# Access Compliance Report Public Rights-of-Way (Curb Ramps)

Main Street: HEWES\_ST Cross Street: EL\_CARMEN\_AVE Location: NE

ADA ID: RPAT211020083646 Ramp Type: Type 1 - Perpendicular Diagonal Initial Pass/Fail: Pass Overall Compliance: No Severity Score: 4

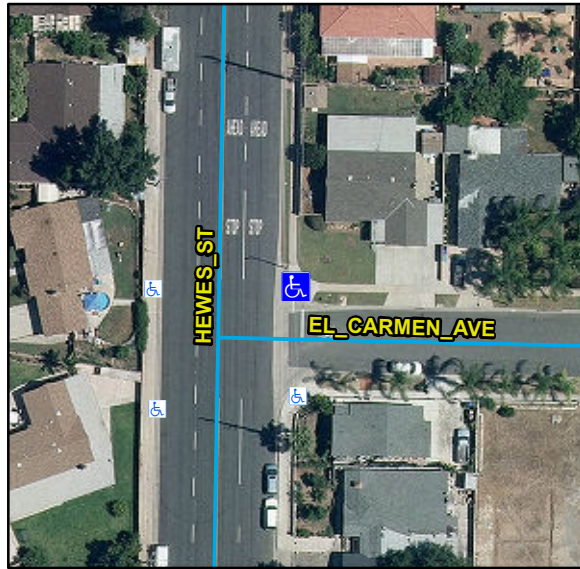
| Compliance | Description                           | Data | Compliance | Description                   | Data   |
|------------|---------------------------------------|------|------------|-------------------------------|--------|
| N/A        | Landing Length (in)                   | 46   |            |                               | Sloped |
| N/A        | Landing Movement Obstructed?          | Yes  | Yes        | DWS Contrast                  | Yes    |

Remove & Replace Landing.

R304.2.1, STD 1115
